SHEARON HARRIS NUCLEAR POWER PLANT, UNIT 1

AMENDMENT TO FACILITY OPERATING LICENSE

Amendment No. 46
License No. NPF-63

ATTACHMENT TO LICENSE AMENDMENT NO. 46

**FIGURE 2.1-1
REACTOR CORE SAFETY LIMITS - THREE LOOPS IN OPERATION**

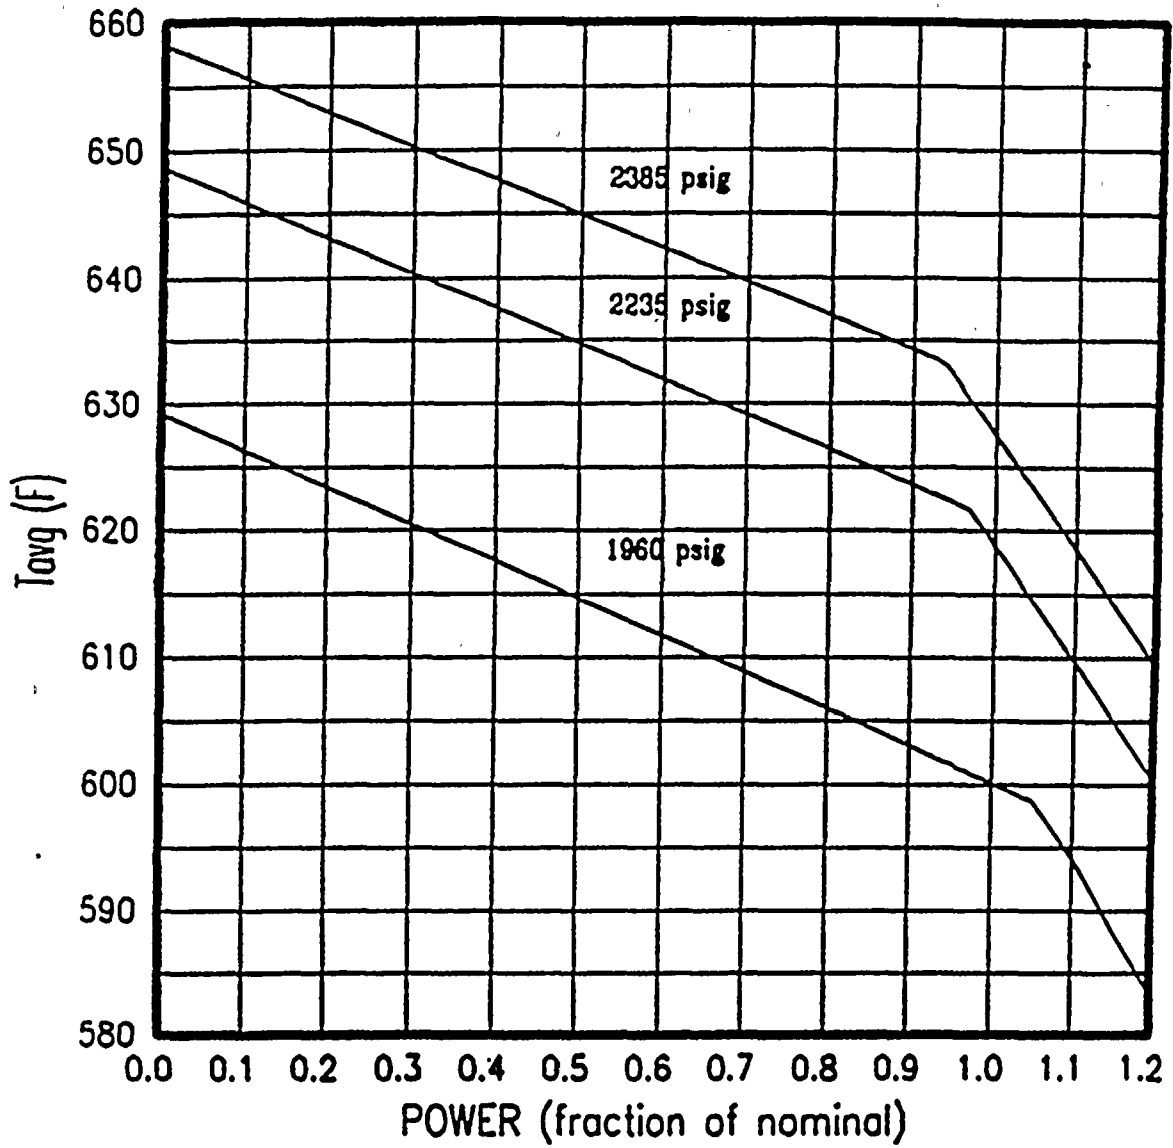
The curves of Figure 2.1-1 show the loci of points of THERMAL POWER, Reactor Coolant System pressure and average temperature below which the calculated DNBR is no less than the design DNBR value or the average enthalpy at the vessel exit is less than the enthalpy of saturated liquid.
